St Margarets Chambers
For Charlotte Street Estates

Lightwell Elevations -
Proposed Repairs and
Conditions 1/2

scheme 1907
drwg no. **P(236)**
revision

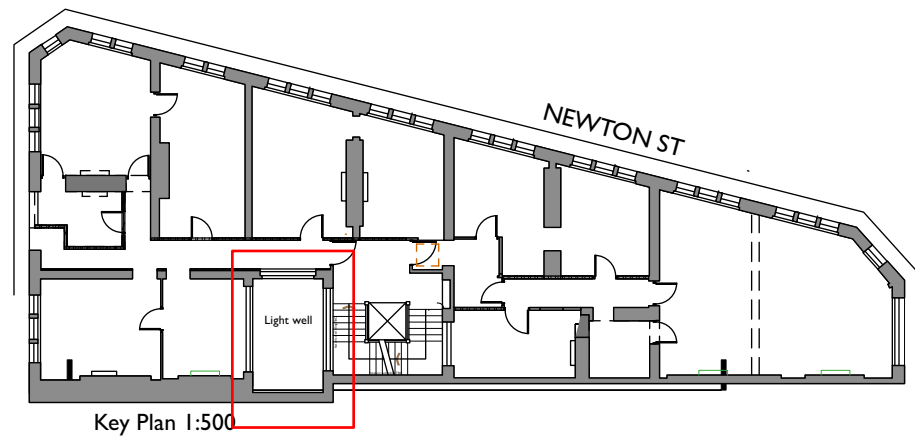
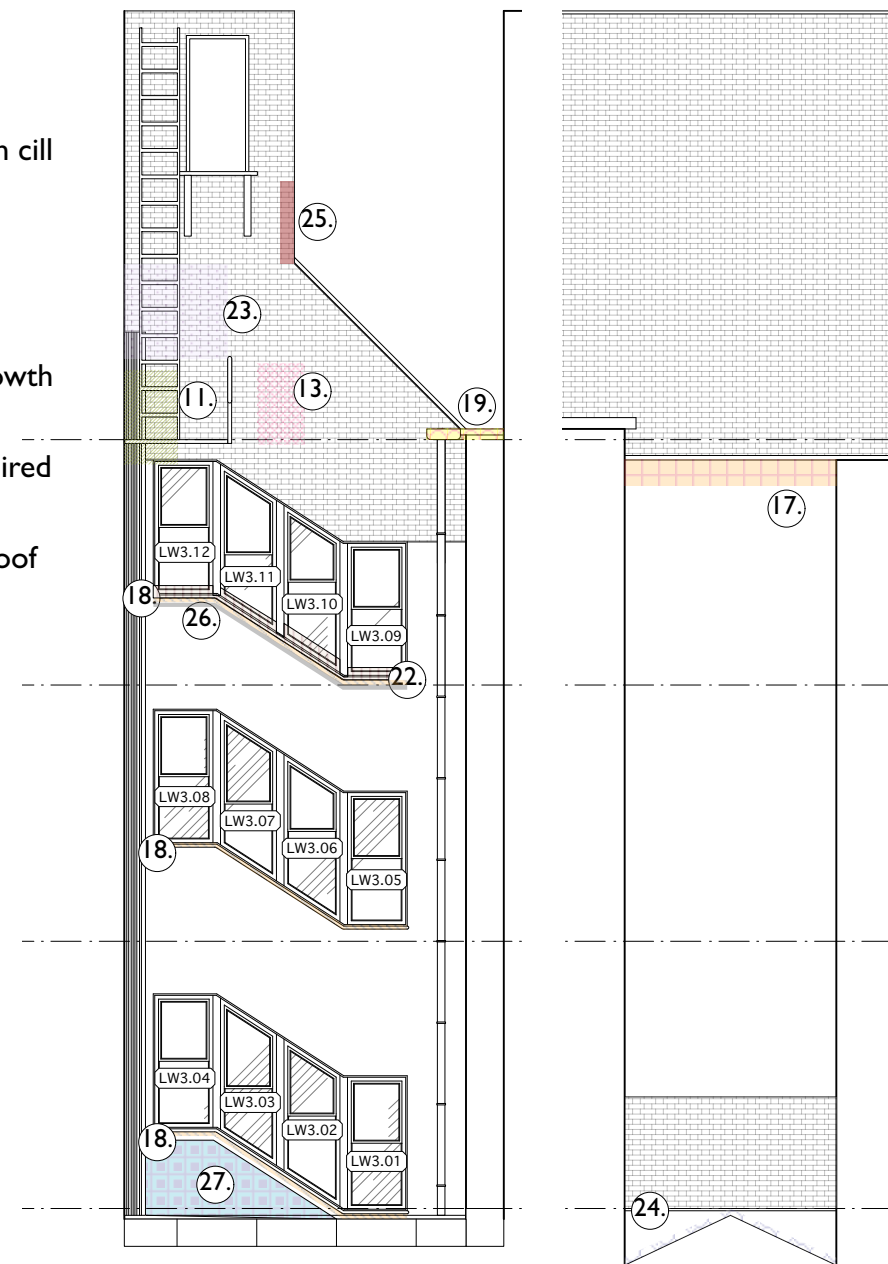
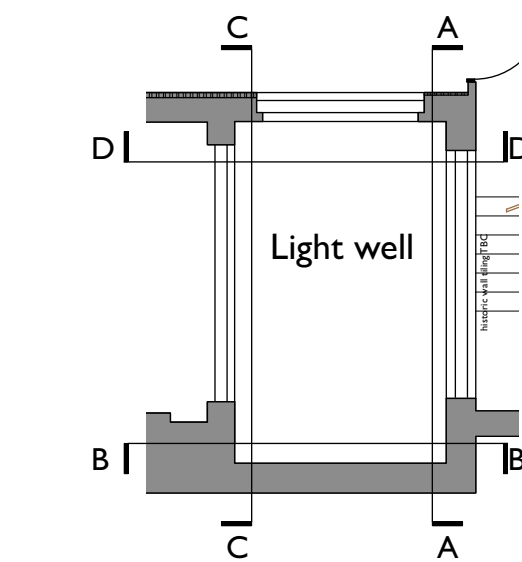
- 1 Sandstone erosion - close inspection required.
- 2 Holes left by redundant fixings - mortar fill in accordance with specification.
- 3 Gaps in brickwork. Close inspection required to inform replacement with matching material.

- 4 Missing pointing between frieze panels. Reinststate in accordance with specification.
- 5 Redundant plant equipment carefully remove and make good fabric in accordance with specification.

- 6 Eroded sandstone coping. Close inspection required. Replacement matching stone inserts may be required to prevent further deterioration.
- 7 Rusting lintels Clean off and repaint in accordance with specification.

- 8 Biological growth to be removed from roof level.
- 9 Coping water staining. May require repointing. Close inspection required.
- 10 Previous repairs to sandstone. Poorly matched aesthetic and presumed composition, but no evidence repairs are causing damage to surrounding historic fabric. Add to building maintenance plan for regular monitoring.

- 11 Biological growth to stone to be cleaned in accordance with specification.
- 12 Water staining may be caused by missing pointing. Close inspection required to inform repair strategy.

- 13 Signs of cracking. Further inspection required on site.
- 14 Redundant cables/lights/alarm box. Carefully remove
- 15 Residue from former sign to be cleaned off sandstone. Method pending site trials.

- 16 Existing timber to be carefully removed from brickwork

- 17 Clean off atmospheric dirt from glazed tiles
- 18 Redecorate cill
- 19 Clean-out gutters
- 20 Missing slate to be investigated once high level access provided
- 21 Repair and redecorate timber window frame and rotten cill
- 22 Clean concrete cill
- 23 Reinststate missing pointing
- 24 Inspect felt roof
- 25 Loose board and flashing to be repaired
- 26 inspect stone cill. Possible damage causing biological growth and staining to wall
- 27 Paint flanking and signs of damp further inspection required

Allow for the renewal of gutters and rainwater outlet to roof
